Canyon Power Plant

(07-AFC-9C)

Amendment 1

Submitted to the
California Energy Commission

City of Anaheim Major Water Facilities Map

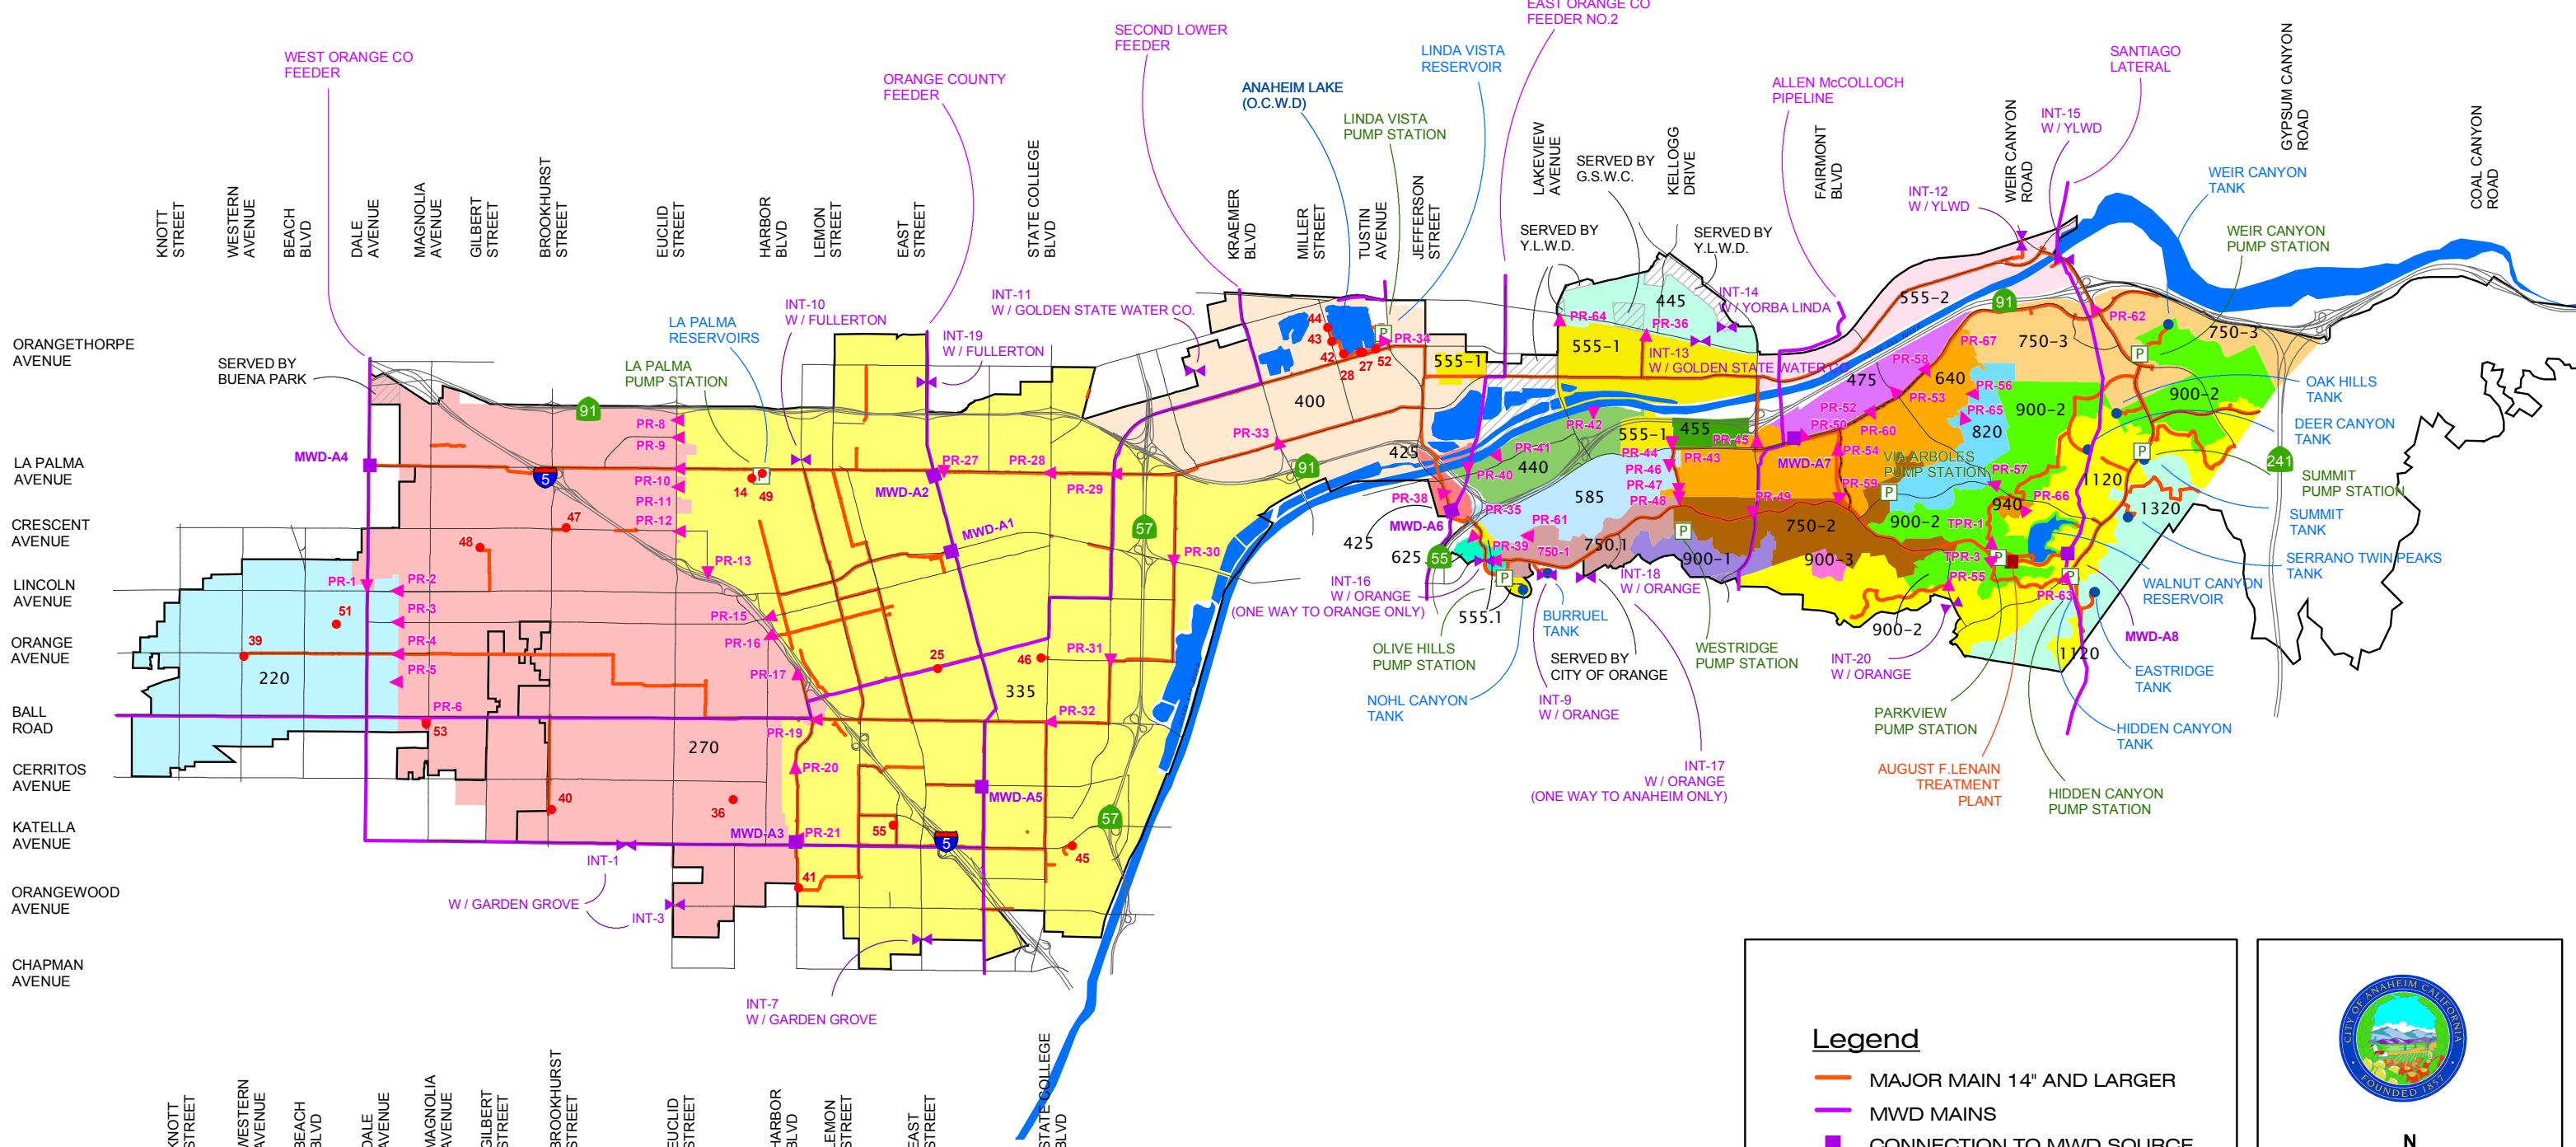
Attachments 1a and 1b present a map of the COA Major Water Facilities and Data Sheet, respectively. Attachment 1a indicates that Well 28 is located in Pressure Zones 400/555, along with 4 other wells (Well Nos. 42, 43, 44, and 52). Attachment 1b shows that the wells in Pressure Zones 400/555 have well depths of between 364 to 1480 feet and are screened between 247 to 1450 feet. SCPPA is requesting to be allowed to use any of the wells in Pressure Zones 400/555 to provide up to 11 acre-feet of construction water consistent with the project's final decision.

SCPPA is requesting approval to receive groundwater from select wells located in Pressure Zones 400/555 (see Attachments 1a and 1b). The wells in Pressure Zones 400/555 draw water from the same groundwater aquifer as Well 28 (see footnote 1). The Final Decision concluded that the use of raw groundwater for CPP construction water supply for dust suppression and non-potable water uses "That temporary use of groundwater will not significantly affect other users of groundwater in the project area."² SCPPA is not proposing to increase the **total quantity, nor does the amendment propose to increase the instantaneous draw** of groundwater used. Therefore, no impacts to groundwater resources are expected beyond those analyzed during the project licensing.

SCPPA proposes a revised Condition of Certification Soil & Water-3 in Section 4. The revised condition allows the use of groundwater from COA Well Nos. 42, 43, 44, and 52.
